After Mike's visit

TB33w3b(h) DRAFT 10/4/19 3.3 dbFh362b

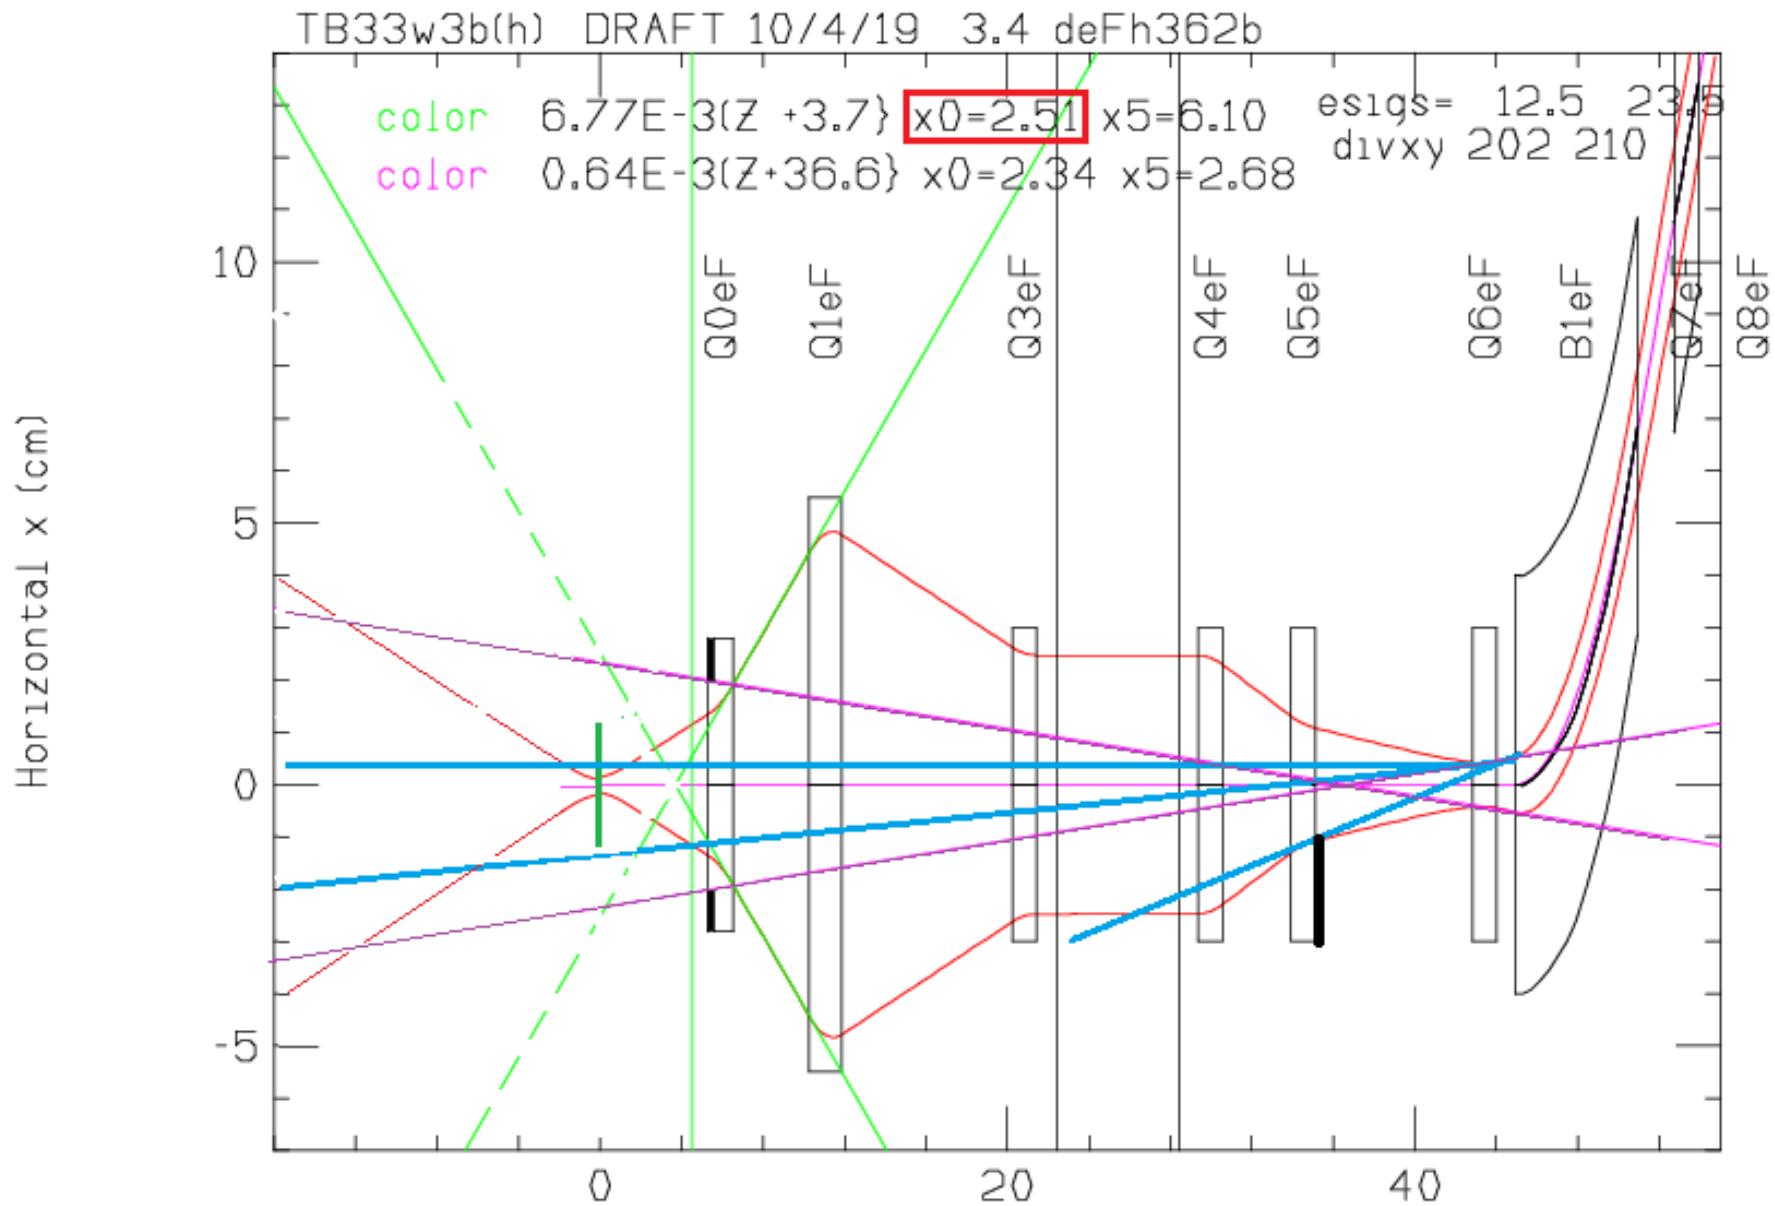
Add bend in Steve's lattice

X Fans from the bend

min IP pipe size > 5.02 cm

SR in crab

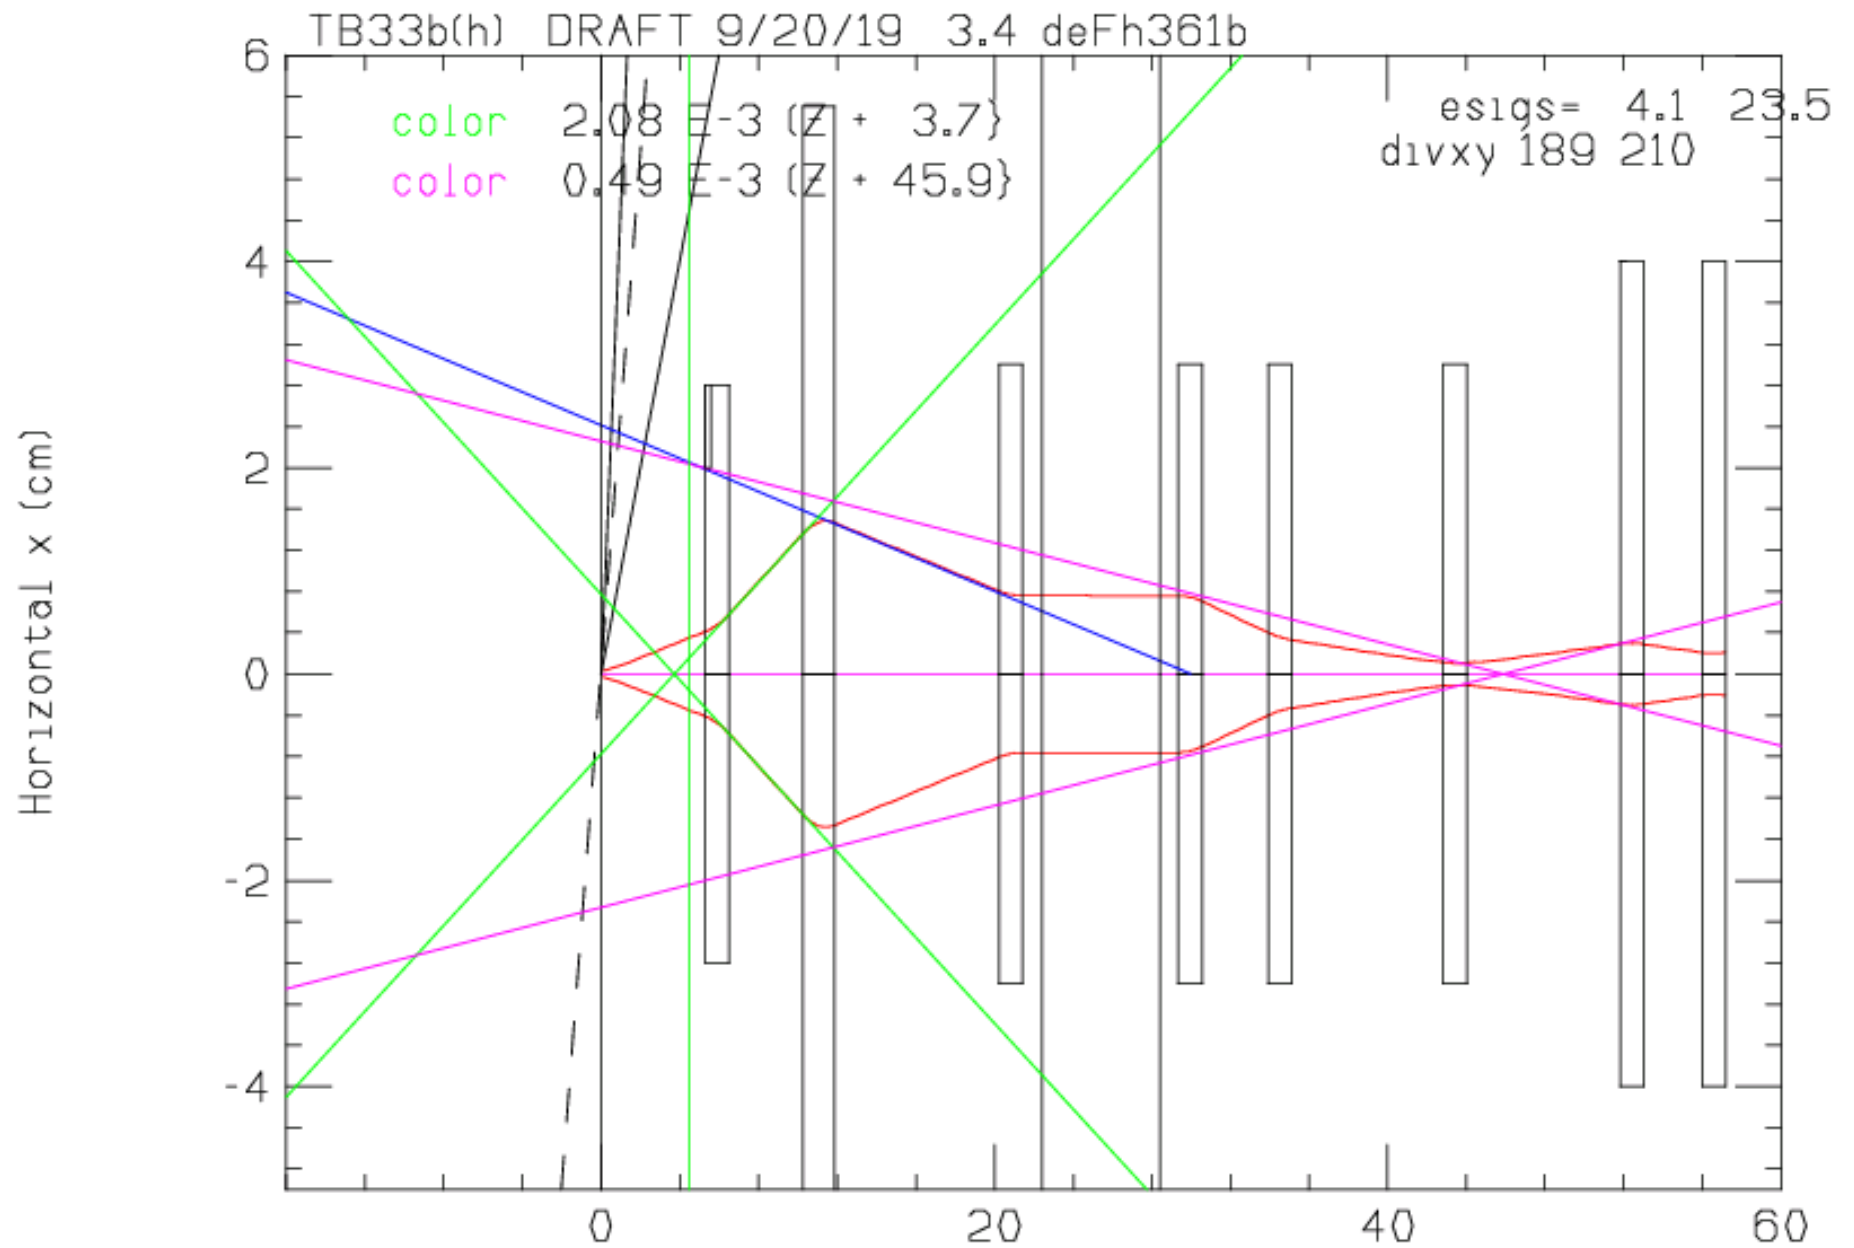
Fan at IP in x even at 4.1 sigma

Proposed conical mask near IP

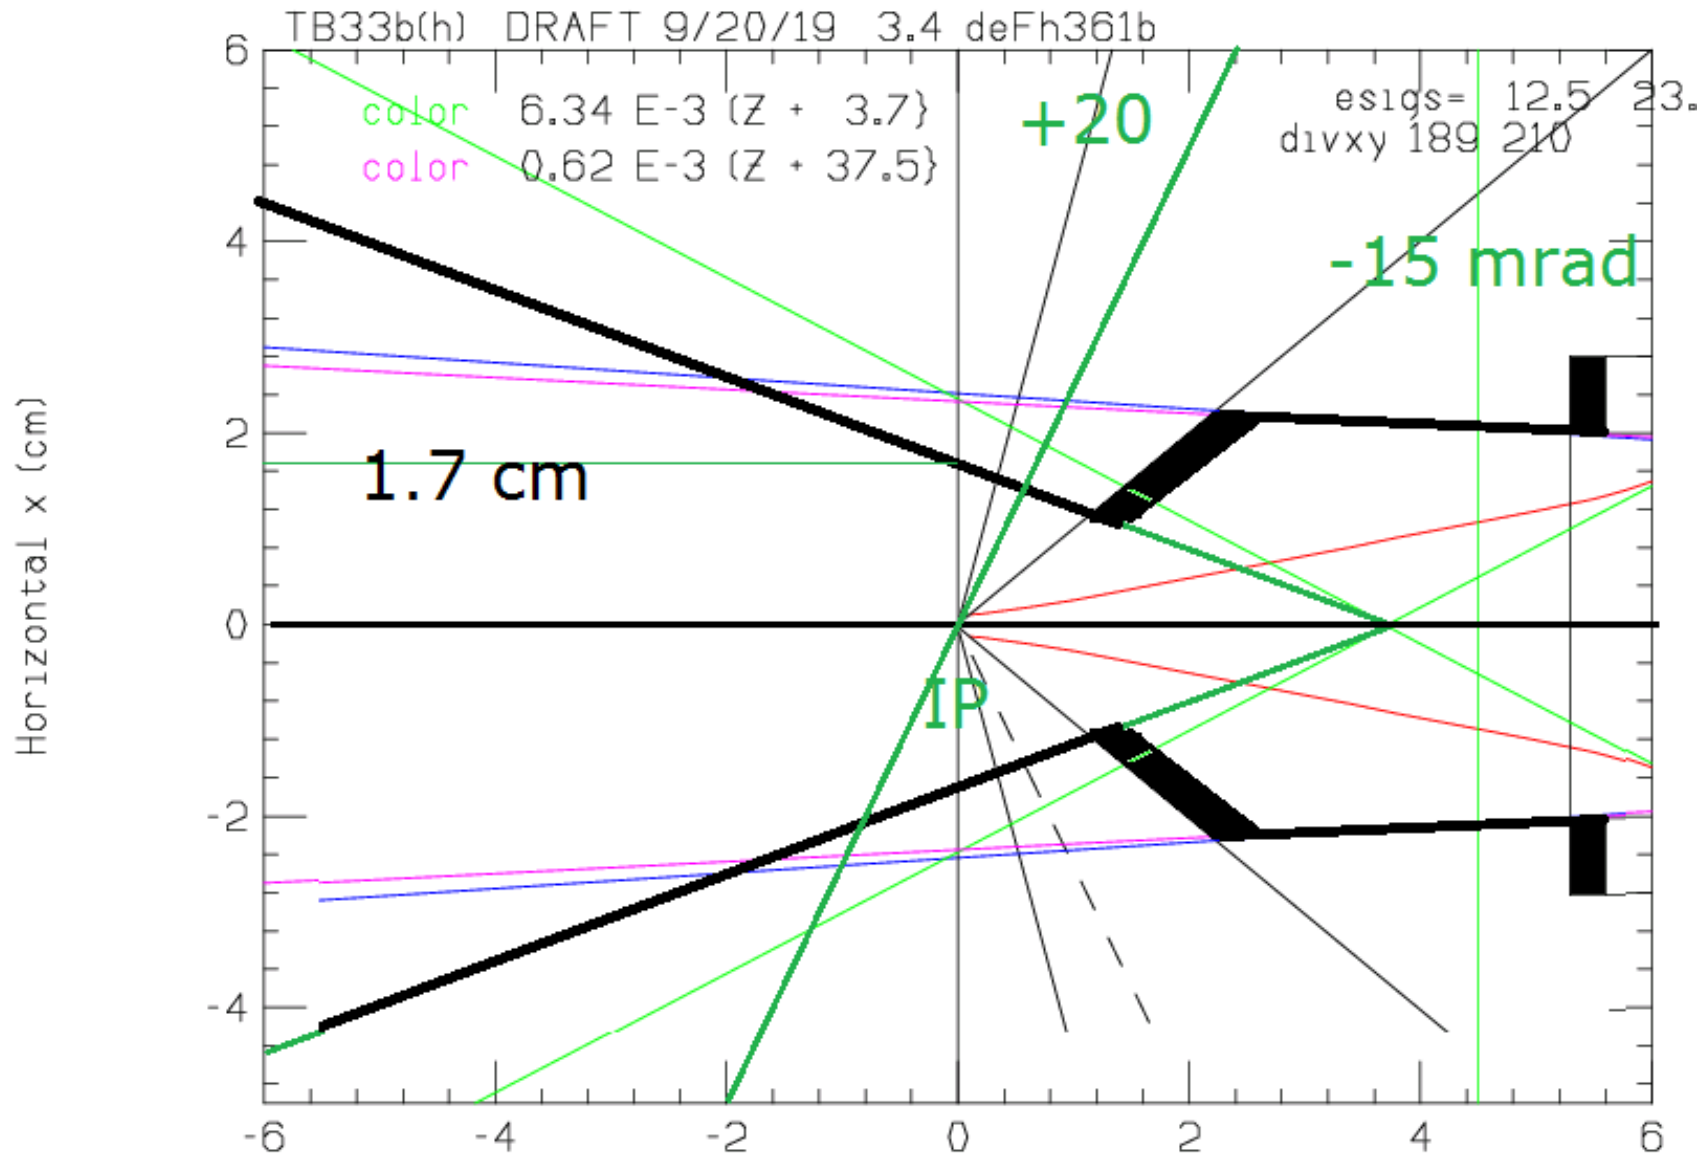
allows x pipe rad of 3.4 cm

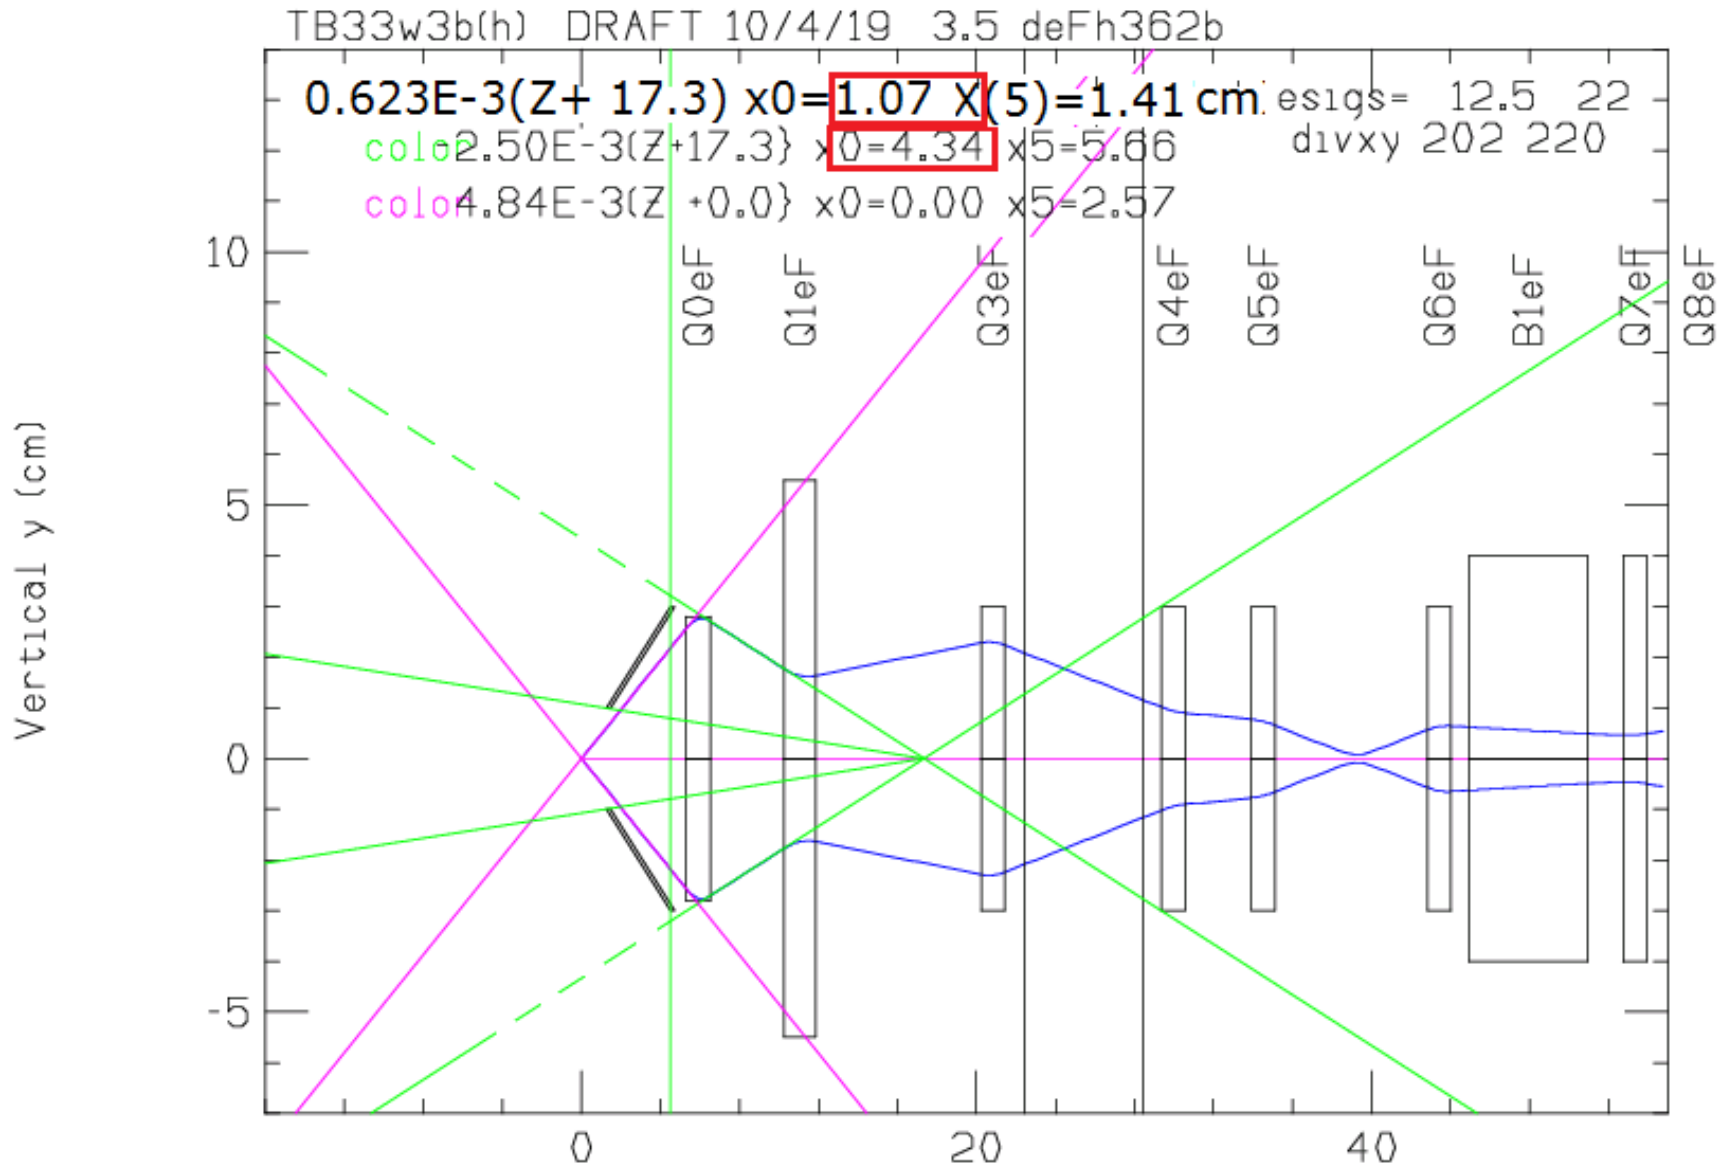
Fan in y and 22 sigma with conical mask

No mask at Q0eF to allow the 22 sig

Baseline Layout

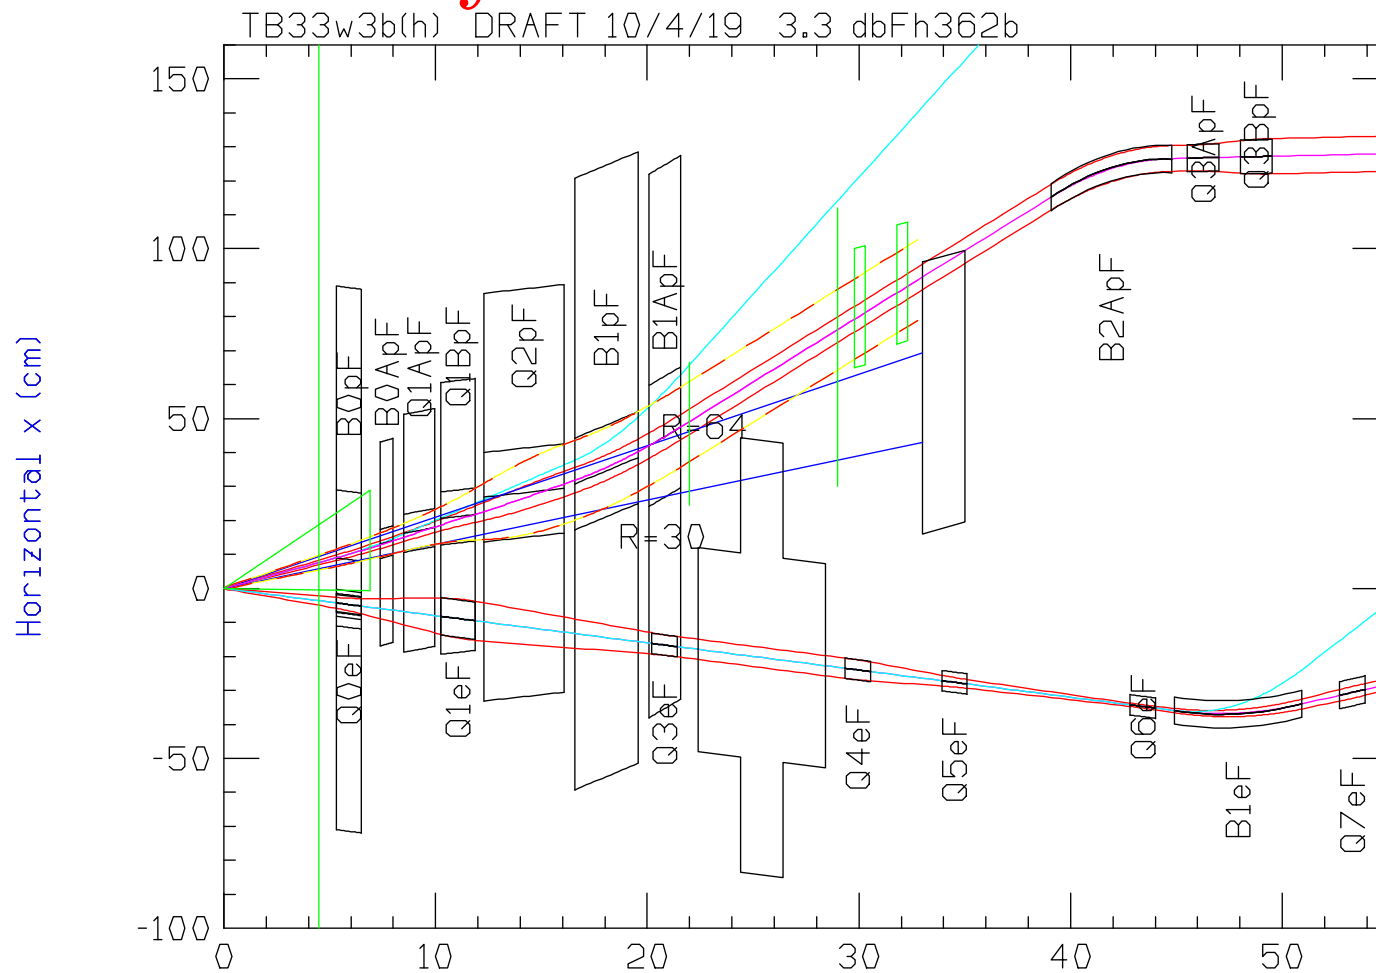
Can Steve move the bend back 7 m for Option 1?
or the crab beyond the bend for option 2 ?

No room for crab eF
